## **11.0 PLANT SYSTEMS**

### **11.2 AQUEOUS POLISHING PROCESS AND CHEMISTRY**

#### **11.2.1 CONDUCT OF REVIEW**

**Figure 11.2-1 Simplified sketch of the high alpha waste system**

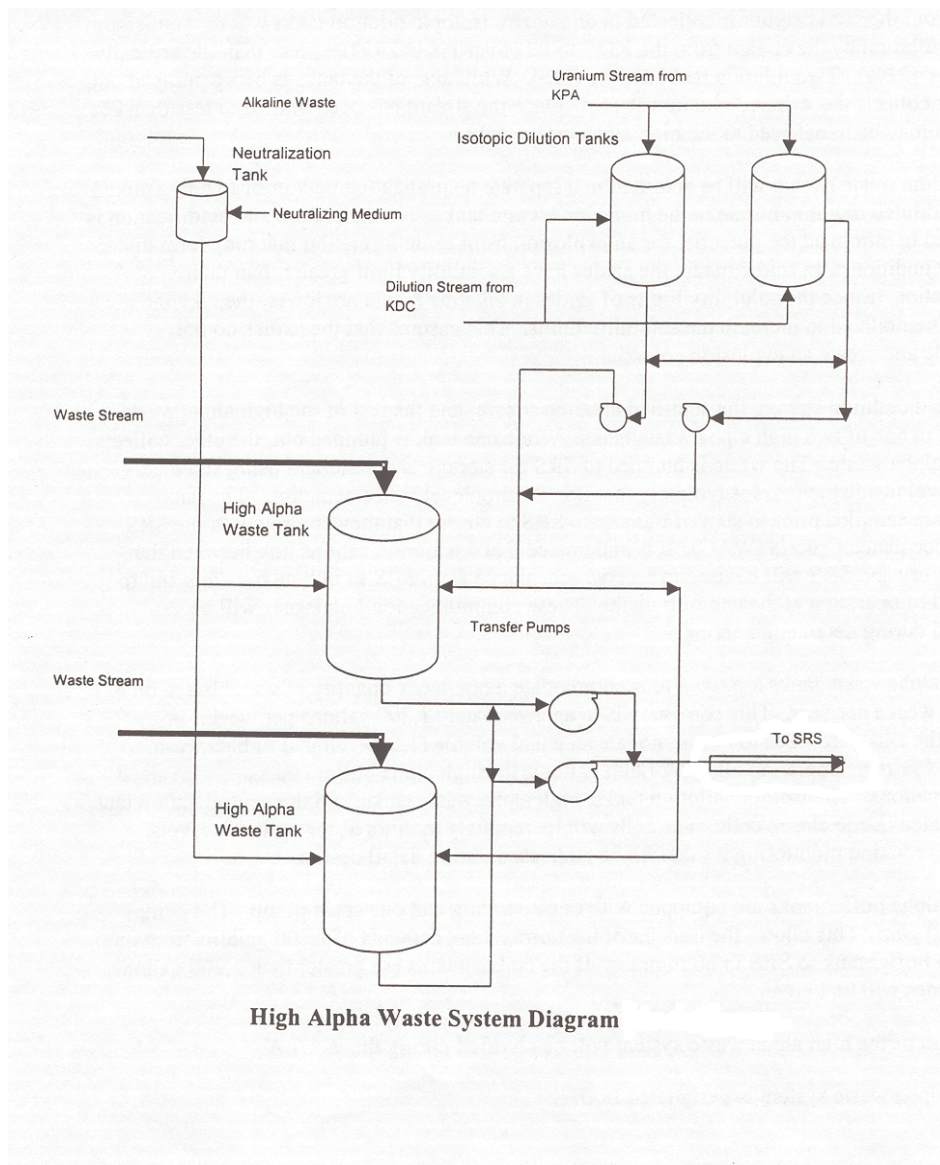
The applicant states the final design of the high alpha waste system will be clarified in its license application (Reference 11.2.4.7). The applicant has designated the high alpha waste system as IROFS (Reference 11.2.4.1, RAI 135). In its review, the staff could not identify the PSSCs associated with the IROFS identified by the applicant and the associated design bases. The staff identified PSSC and design basis information associated with the applicant's use of the phrase, "The high alpha waste system is designated IROFS," in the waste system as an open item. The applicant needs to provide additional PSSCs and design basis information or provide sufficient justification that none are necessary.
